INITIAL FIRE SAFETY INSPECTION REPORT

Karnaphuli Sportswear Industries Ltd. (Extension)

RSC ID: 25961

Date: 23-Jan-2025

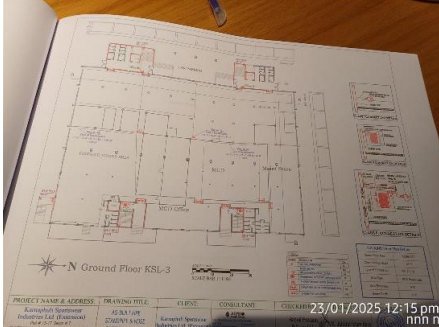
F-6	Fire Rated Construction	Unsealed penetrations has been observed in the fire rated ceiling assemblies due to expansion joint, plumbing pipe, cable penetration. Location: KSL-3 Building, Kitchen & Canteen Building, and Gas Generator House.	Seal all penetrations and openings in floor/ceiling assemblies to maintain the fire separation at least by 3-hr. The used sealer shall be 3rd party certified and installation shall be as per manufacturer's datasheet. Or Provide a minimum 2-hr fire rated shaft to separate the utility risers from each floor if required.	Within 3 months
 The middle row of the table contains three photographs. The first photo on the left shows a close-up of a hole in a dark, textured ceiling with a green cable running through it. The middle photo shows a red fire door in a hallway with a green 'EXIT' sign above it. The third photo on the right shows a hallway with a yellow arrow pointing to a ceiling vent. All three photos have a timestamp '23/01/2025 12:54 pm' and 'nnn n' in the bottom right corner.
